# RECORD OF DECISION

K - Fulton Works  
Operable Unit Number 01: Plant Site and Near Off-site  
Brooklyn, Kings County  
Site No. 224051  
July 2015

Prepared by  
Division of Environmental Remediation  
New York State Department of Environmental Conservation

### **K-Fulton Works Operable Unit No.1: Plant Site and Near Off-site Brooklyn, Kings County, New York Site No. 224051**

**Figure 5**

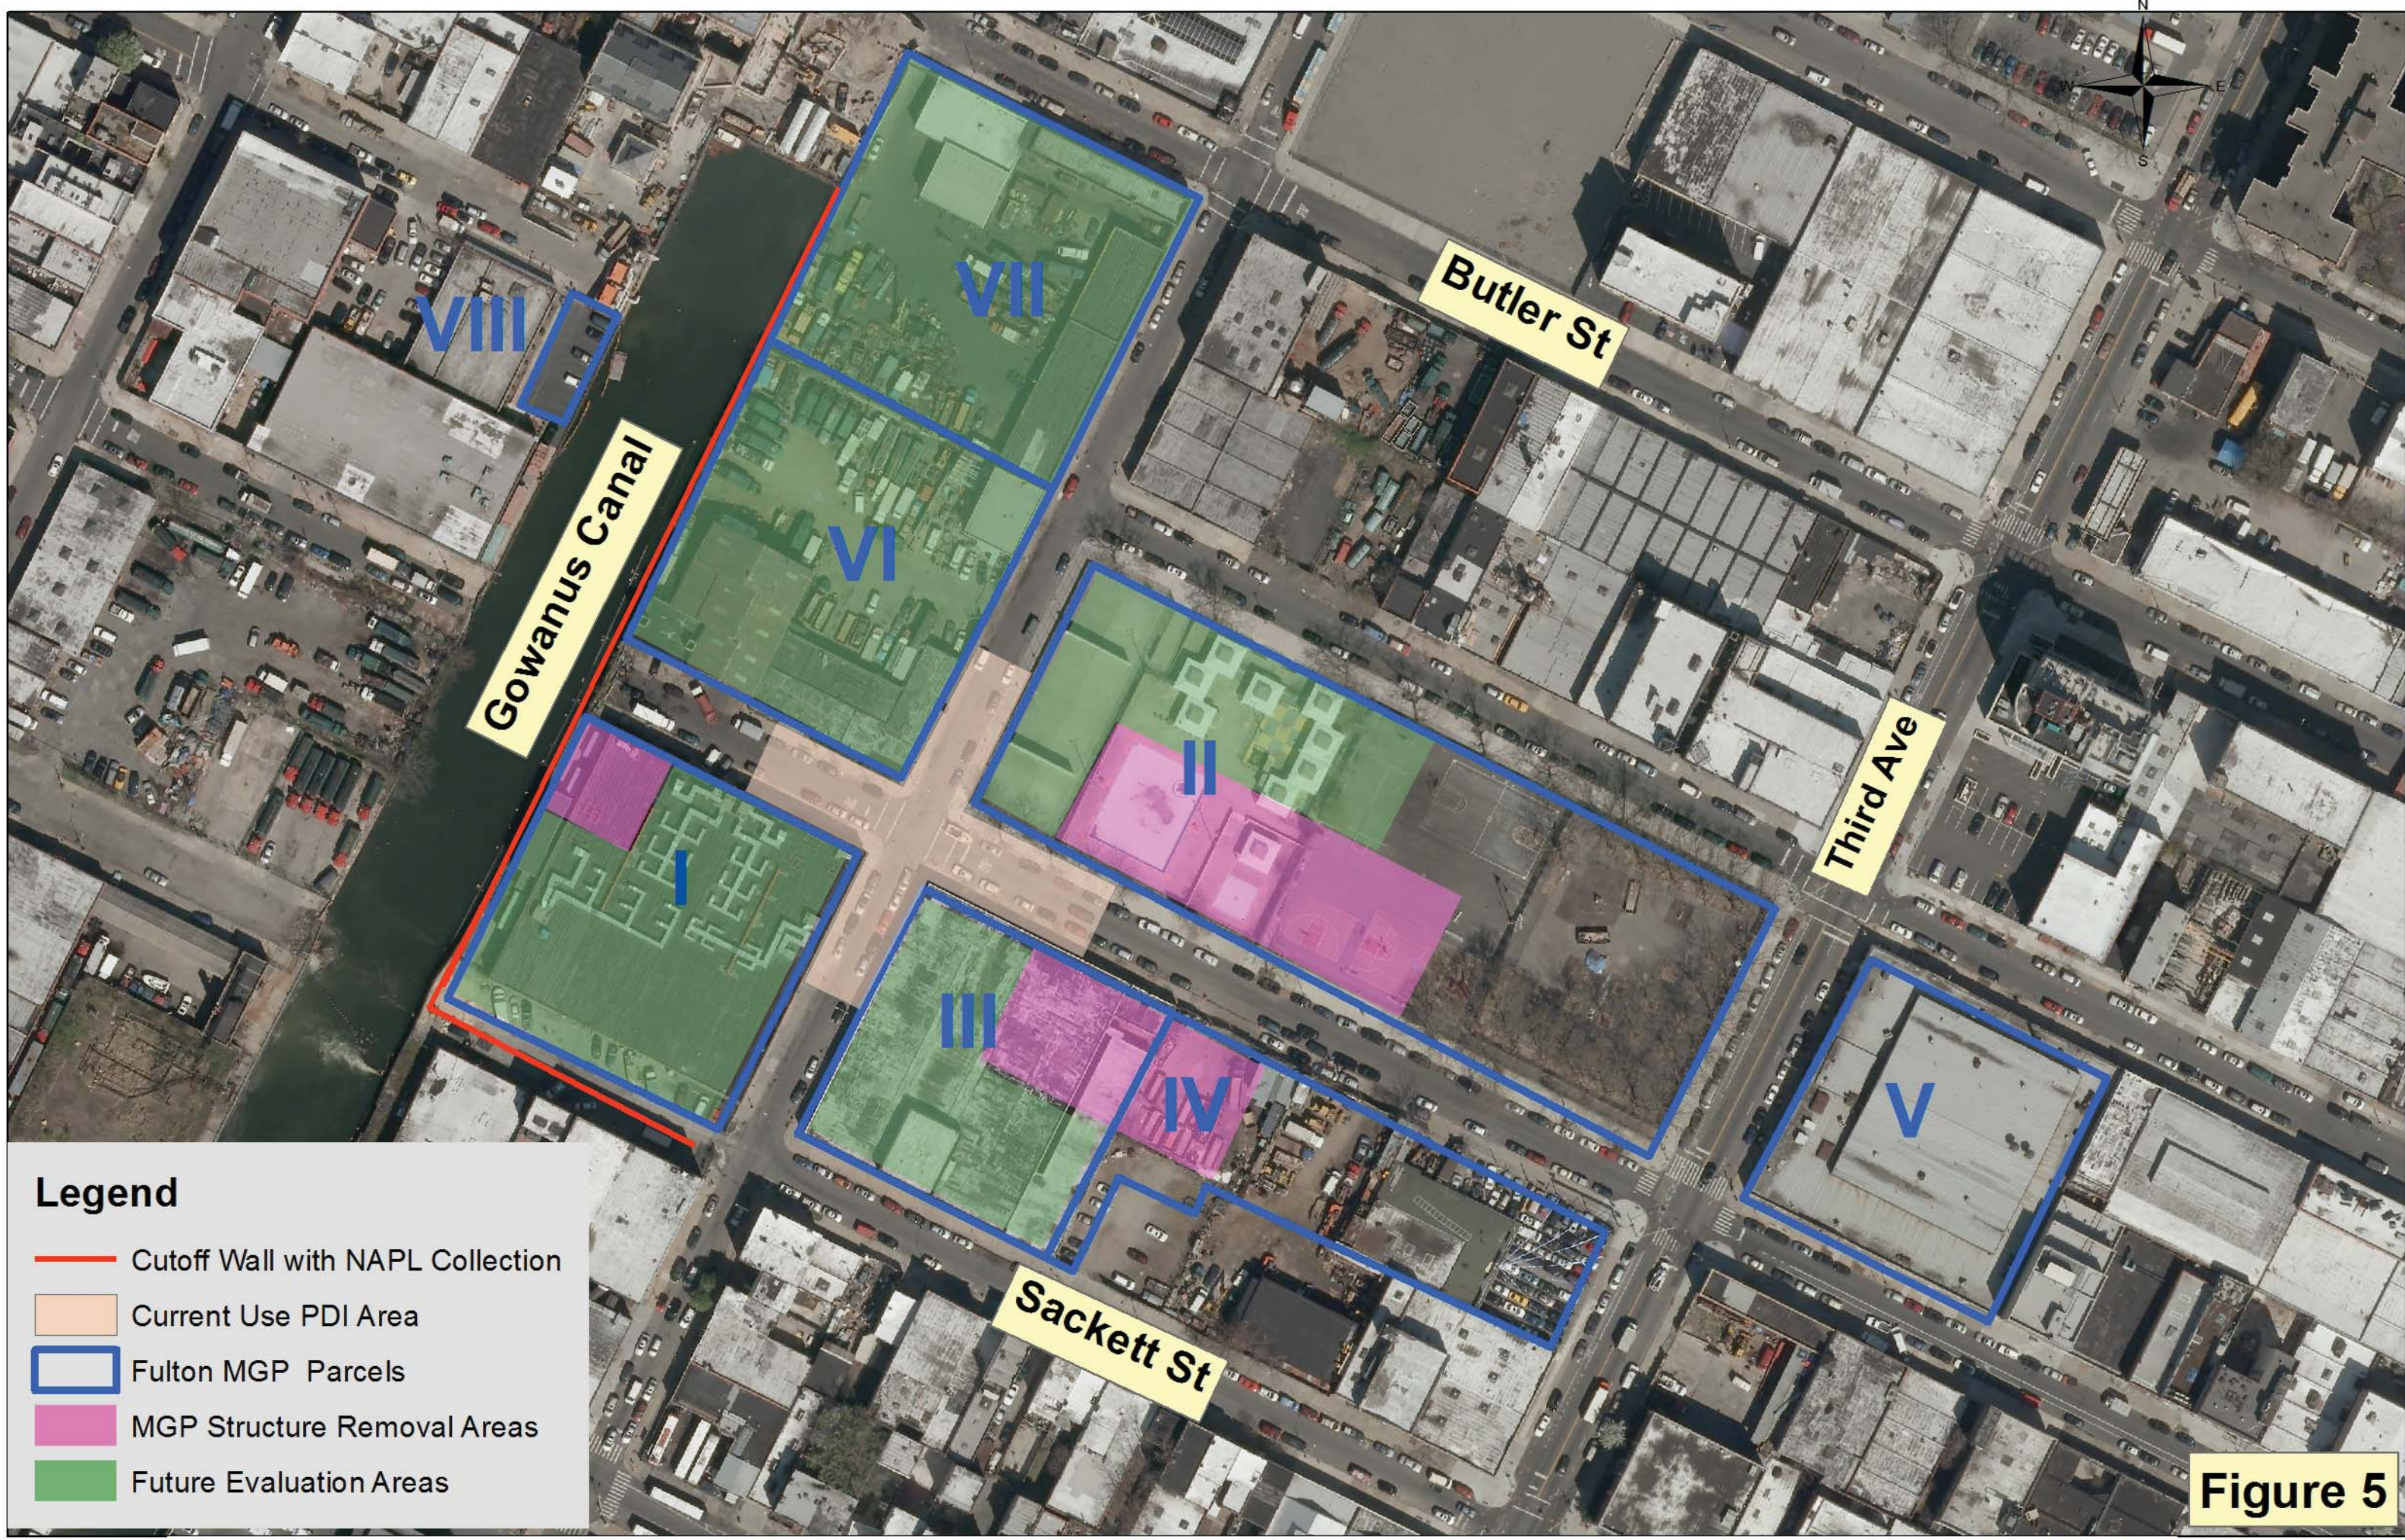
**COMMENT 17:** *Page 11, Section 7, Summary of the Proposed Remedy, Subsection 2. Containment: "The final wall depth and configuration, including the need for hydraulic relief and associated treatment, will be determined during the design of this project."*

Please clarify whether hydraulic "relief" can be broadly interpreted to mean hydraulic "control." National Grid's groundwater modeling, to date, has shown that at the top area of the Canal, there exist high hydraulic conductivities resulting in significant groundwater discharge in the Canal and significant upwelling at the bottom of the Canal. Because tar-related contamination is transported to the Canal by the groundwater, the potential need for hydraulic control, rather than just hydraulic

If modeling predicts lateral movement of contaminated groundwater (or even coal tar) around the end of the wall, wing walls and associated treatment may be required, as noted in Figure 5 of the ROD. If it appears that MGP-contaminated groundwater may flow around the wall, the ROD will require in-situ treatment to address contaminant migration to the canal. In-situ treatment options are preferable to hydraulic control measures, since they are simpler to install and operate, and use less energy over the long term. DEC and National Grid have had considerable success, for example, with treating heavily MGP-contaminated groundwater with simple oxygen injection systems. Such systems can effectively treat MGP contaminants eliminating them from groundwater prior to its reaching the canal. DEC notes that any treated water leaving the site would be expected to pass through coal tar saturated sands remaining below the dredged canal bottom and become re-contaminated prior to its discharge to the canal. In the sections of the canal adjacent to the Fulton site, where in-situ solidification (ISS) of sediments will be conducted by EPA, the low permeability of the ISS mass is likely to prevent the discharge of groundwater to the canal, potentially causing groundwater mounding in the upland area. Hydraulic relief “windows” in the canal bottom may be necessary to allow groundwater discharge. The design for these areas should include a provision for the treatment of groundwater prior to discharge through these windows since, as identified above, the passage of groundwater through tar-saturated sediment will result in recontamination following treatment at the end of the barrier wall.
